HISTORIC AND DESIGN REVIEW COMMISSION

HDRC CASE NO:	2020-055
ADDRESS:	814 BURNET ST
LEGAL DESCRIPTION:	NCB 549 (814 BURNET SUB'D {IDZ}), BLOCK 9 LOT 18
ZONING:	IDZ, H
CITY COUNCIL DIST.:	2
DISTRICT:	Dignowity Hill Historic District
APPLICANT:	Gaspar Rivera/POMA PROPERTIES LLC
OWNER:	Gaspar Rivera/POMA PROPERTIES LLC
TYPE OF WORK:	COA re-issue request
APPLICATION RECEIVED:	January 16, 2020
60-DAY REVIEW:	March 16, 2020
CASE MANAGER:	Edward Hall

The applicant is requesting a Certificate of Appropriateness for approval to construct three, two story residential structures at 814 Burnet.

4 COLUMN DETAIL SCALE: 3/4"=1'-0"

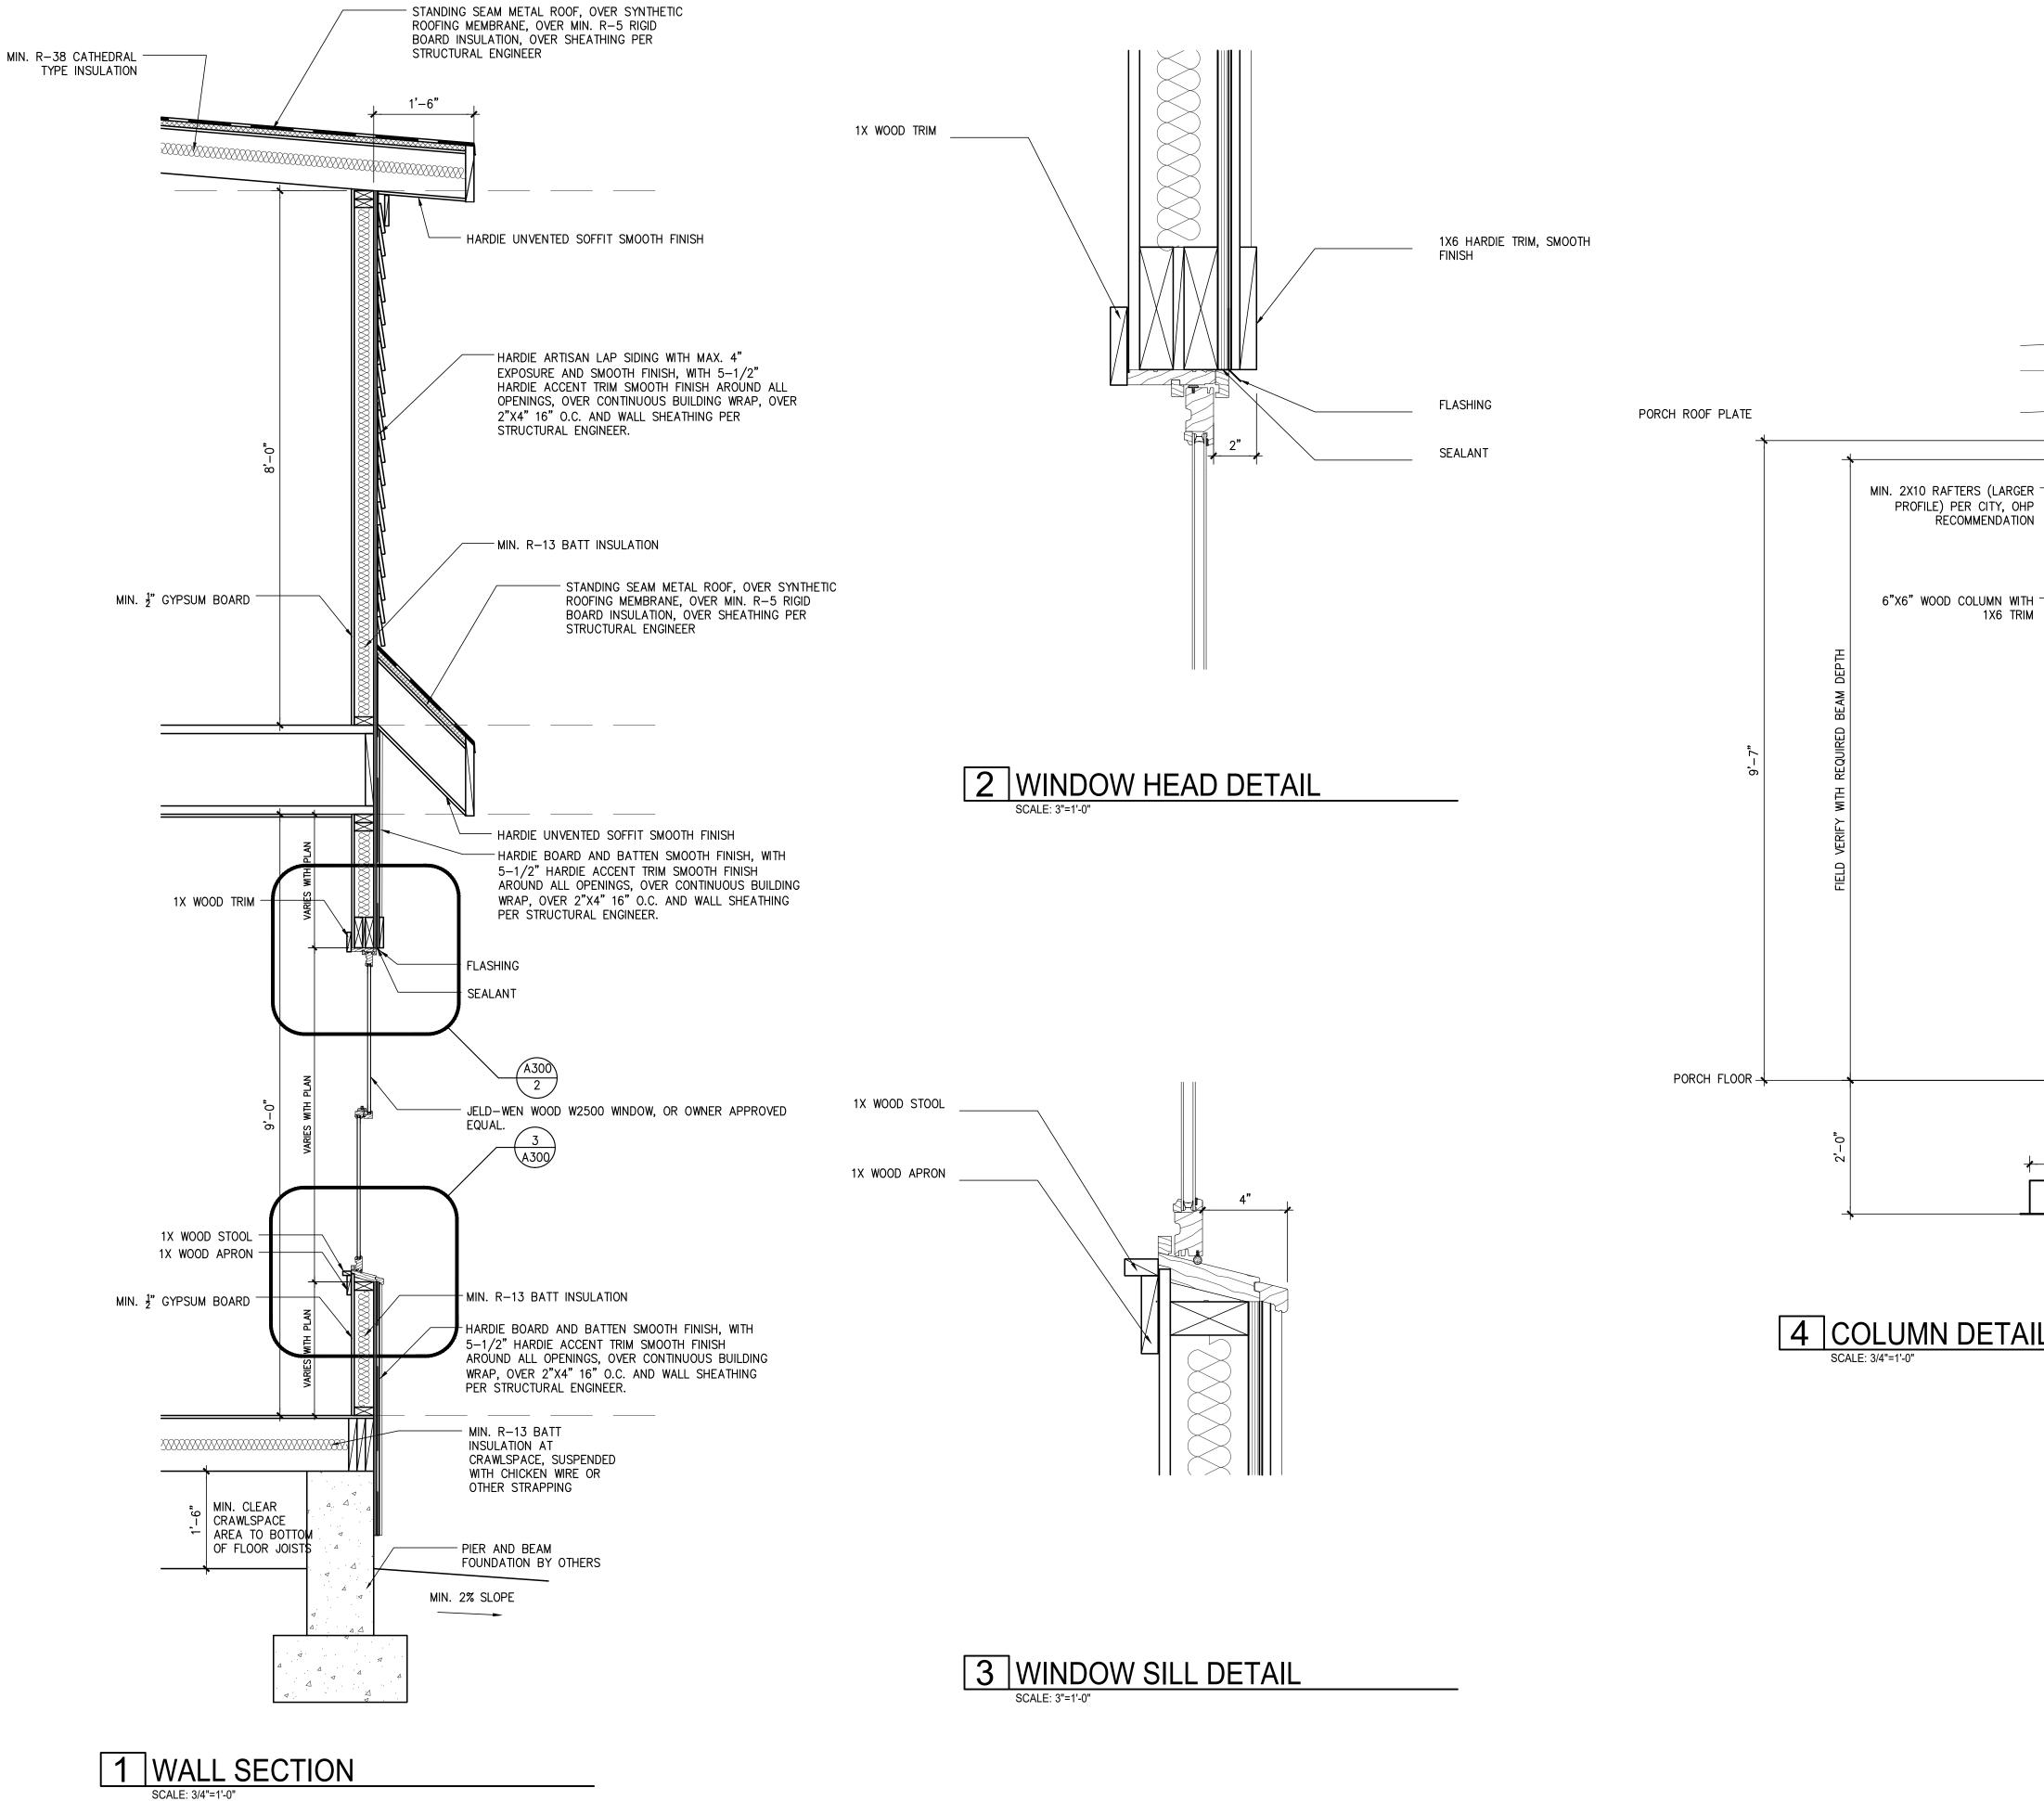
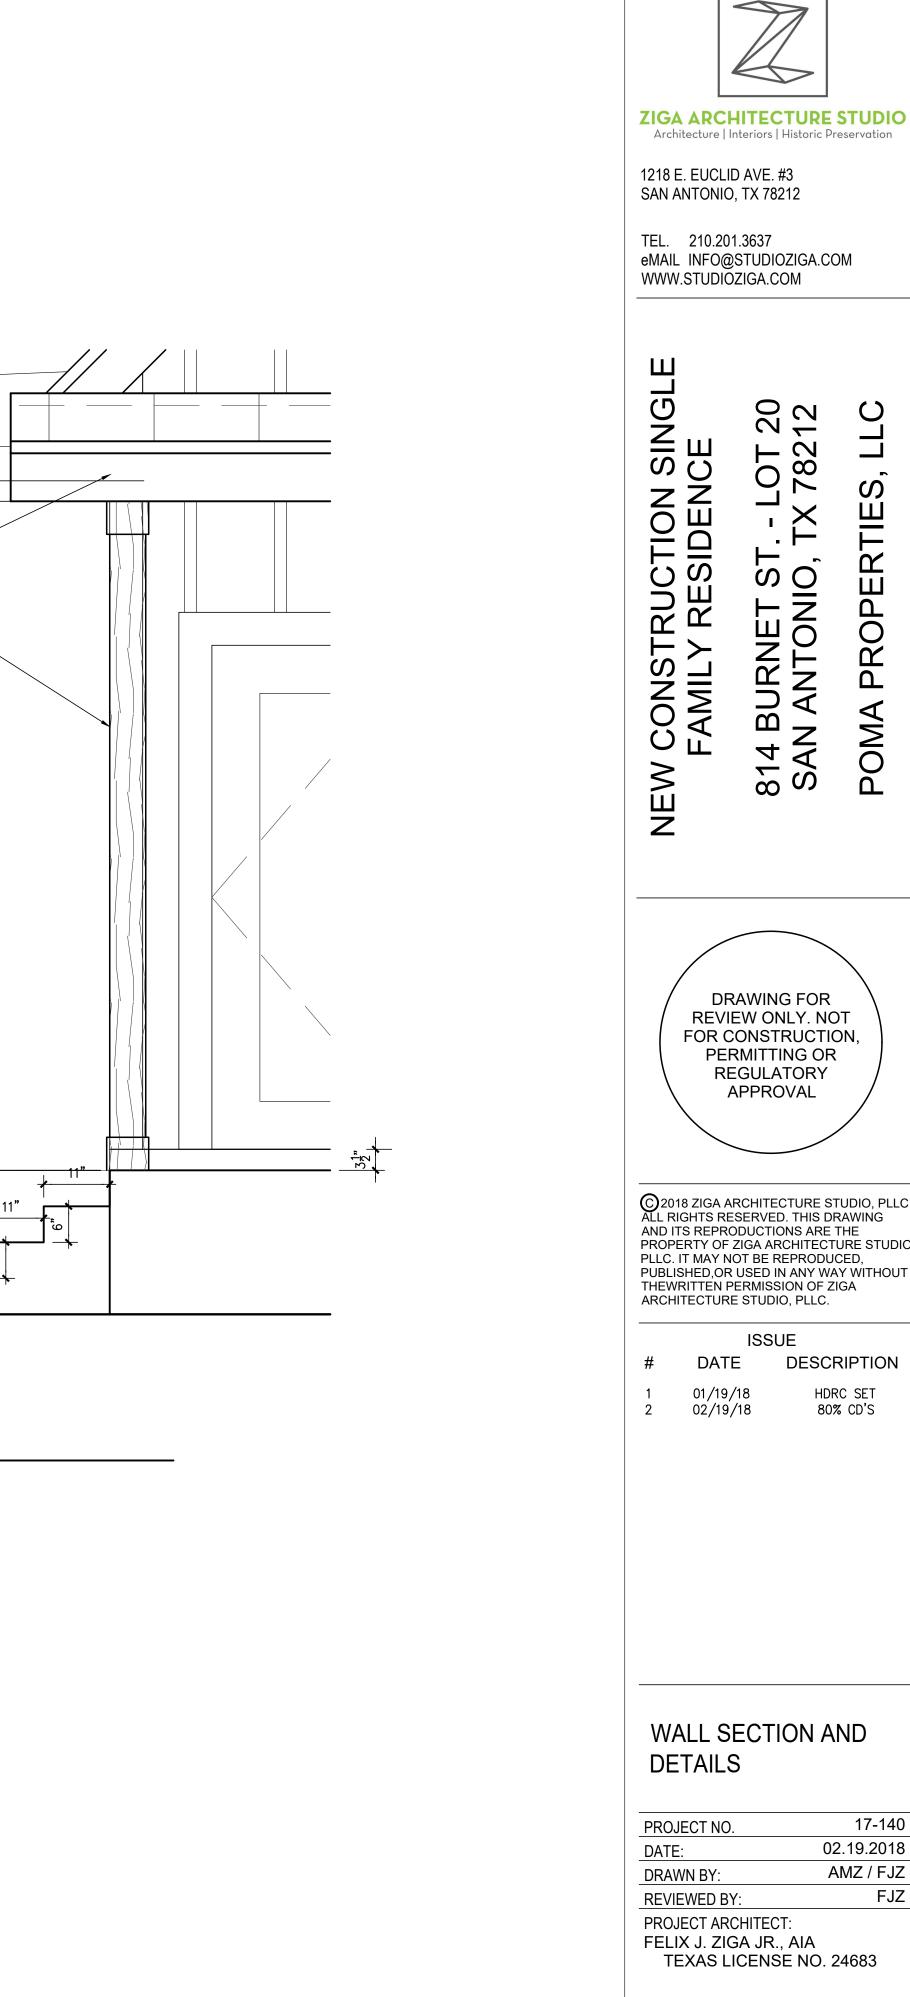
- p. COLUMN DESIGN The applicant has proposed cedar front porch columns; however, at this time has not included a column detail determining trim and dimensions. Staff finds that a column not to exceed six (6) inches in width should be used.
